To: Area Manager, Hollister Resource Area
From: Chief, Division of Resources
Subject: Draft Report of Field Observations, Atlas Mine and Mill Site and Vicinity

DRAFT FIELD OBSERVATIONS REPORT
ATLAS ASBESTOS MINE COMPLEX

Figure 1. ORTHOPHOTOGRAPH OF THE ATLAS MINE AND KC MINE AREA showing main access road, soil (S) and water (W) sample sites, and land disturbance. (Scale 1:24,000)

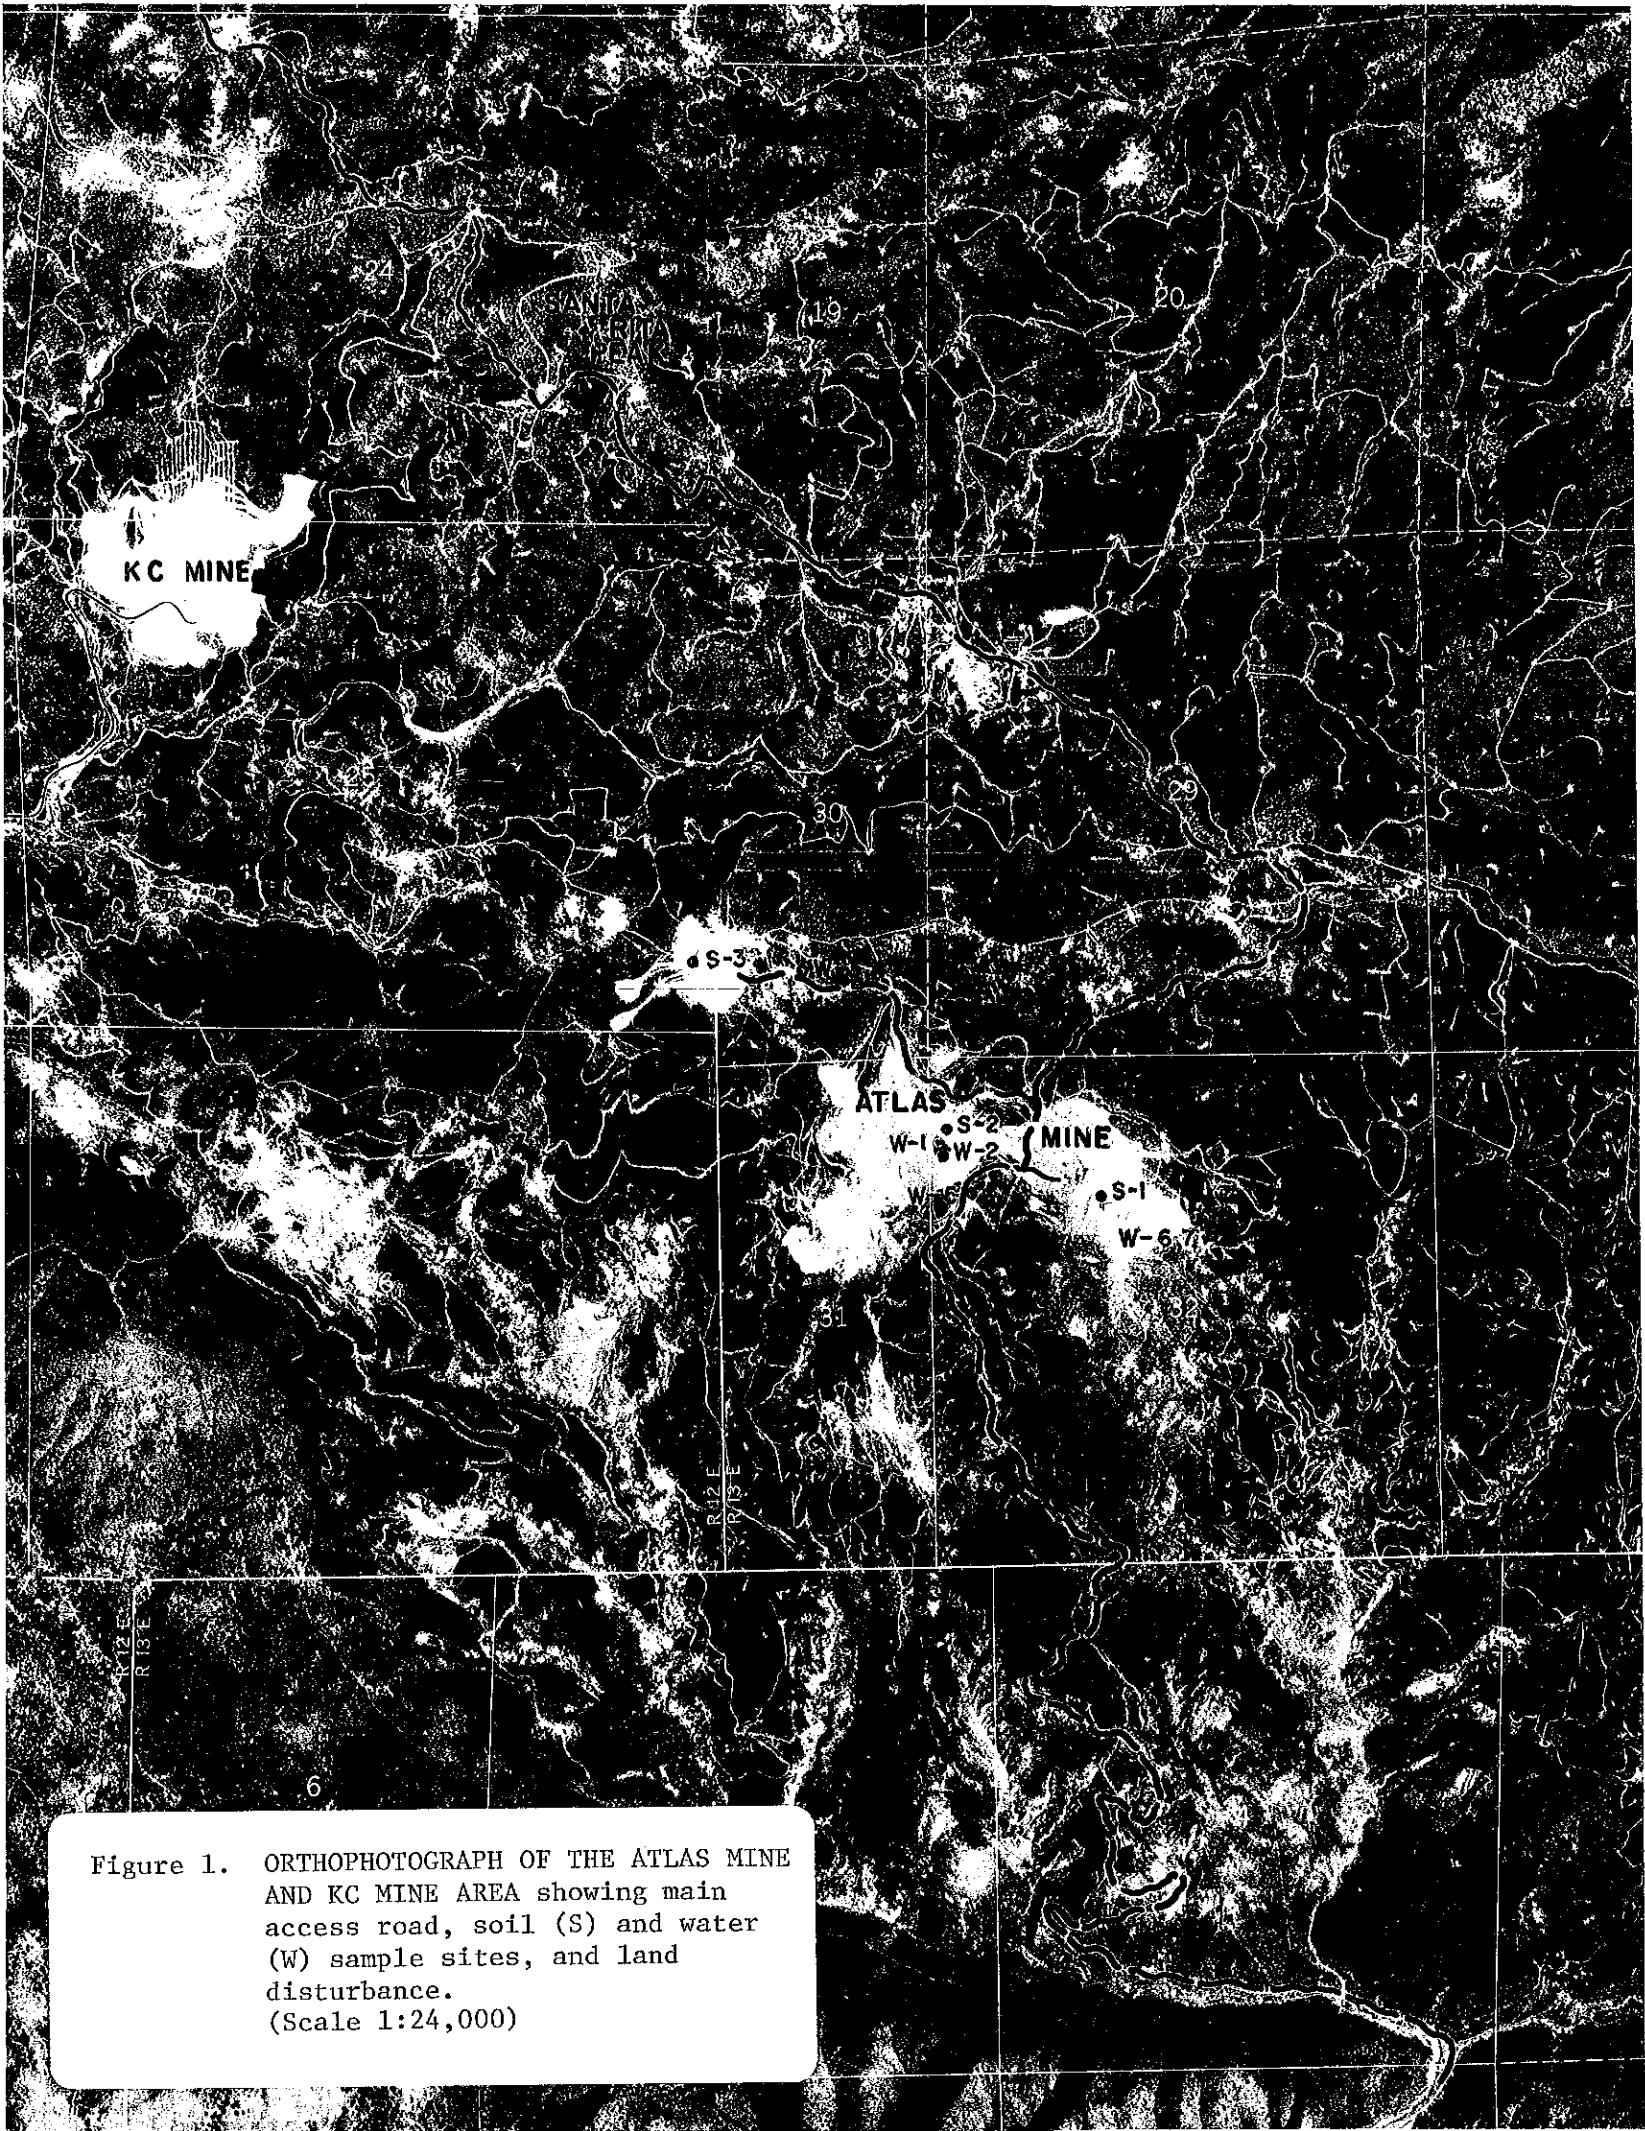
Soil (favorable plant growth materials) source areas are very limited within the Serpentine area. Some very small localized areas could be used; however, extreme caution must be taken to avoid exposing the weathered Serpentine rock or creating an erosion hazard. Stripping concave draw areas for use as spoil disposal areas and stockpiling the limited favorable growth materials for use in providing plant growth materials for surfaces could be effective. This could have been done at the Joe Pit Mine (operated by the King City Asbestos Company) as the adjoining concave drainage is being used for the spoil disposal (Figure 1 and Photo).

There is no visual evidence of mass instability on the tailings dump. We believe that surface and subsurface cracks on the dump are due to soil piping and to poorly understood forces in the spoil pile. We observed mass instability of a general nature at the top of the main ore production pit (Figure 1).

Local BLM people reported that these tailings were saturated with ponded water about June 1 where the road to the upper production area first crosses the tailing pile. On June 14, the ponded water was gone, except for a very small pond on the east side of the road (see W-3/W-4, Figure 1). The source of this water is a small spring located northwest of the mine spoil. This same spring contributes ground water to the lower pond that is reported to be filled with water all year. Saturation of the tailings by discharge from springs can also induce failure of the pile due to high hydrostatic pressures. High pore pressures can take years to develop, but can result in sudden failure of the mine spoil.

We noted that this is a very organized mine operation as viewed from a distance. Time, however, did not allow the opportunity for a thorough inspection of the mine. The orthophotoquad (Figure 1) indicated some potential problems. The waste-rock dump built in the draw east of the mine operation was, at that time (August 1981), ponding water immediately upstream of the dump, suggesting that no drainage facility was installed to pass channel flow through or around the dump. A hydrologic analysis should be made of this basin to ascertain potential flood risks, an item that should be addressed in the revised "Plan of Operation." The SC technical team would be pleased to assist the Hollister Resource Area and Bakersfield District staffs in their review of the revised Plan of Operation when it becomes available.

Seven water sample asbestos determinations by the Transmission Electron Microscopy (TEM) method and soil sample analyses are expected back to us by approximately July 15. Water and soil sample sites are located on Figure 1. These data will be evaluated and discussed in the August 1, 1988 final Atlas report. One soil sample each was taken from the mine area and from the spoil pile for chemical and physical analysis. The purpose was to determine the potential of material for plant growth. Water samples are being analyzed by the R.J. Lee Group at Berkeley.
